Appearance Change of the Inverter Option FR-ABR Brake Resistor

Date of issue	June 2019	Title	Appearance Change of the Inverter Option FR-ABR Brake Resistor	Mitsubishi Electric Corp., Nagoya Works 5-1-14 Yada-minami, Higashi-ku, Nagoya 461-8670 Tel.: +81 (52) 721-2111 Main line
----------------------	-----------	--------------	--	---

Example: FR-ABR-0.4K

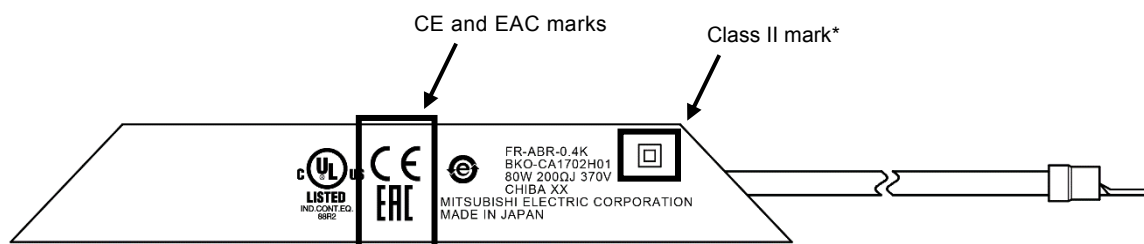
CE, EAC, and Class II* marks will be added to the side of the FR-ABR high-duty brake resistors. The aluminum surface of the resistors will be anodized to prevent damage.
 The change does not affect the quality, performance, or specifications of the products.

Before	After
None	CE, EAC, and Class II* marks will be added.
